AURIX™ TC37x errata sheet

Marking/Step: (E)ES-AA, AA

About this document

Figure 14 **Positive overload on P-pad of a LVDS RX pin pair (both used as inputs)**

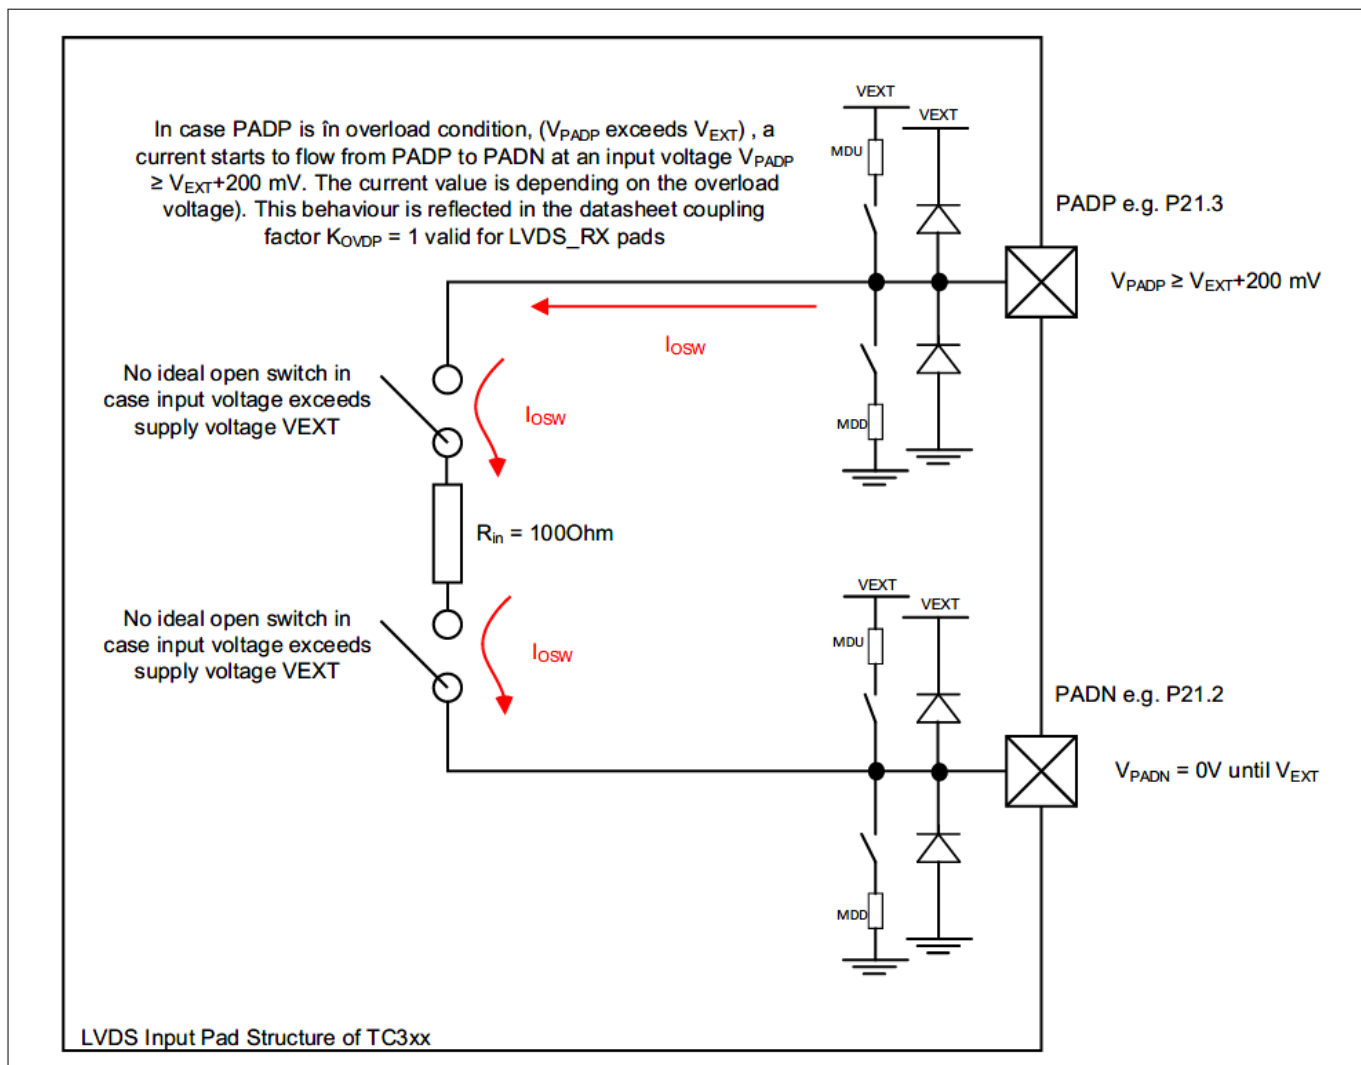
Note: In general, the effect will also occur if the N-pad is used as output, or for a negative overload condition on either the P-pad or the N-pad.
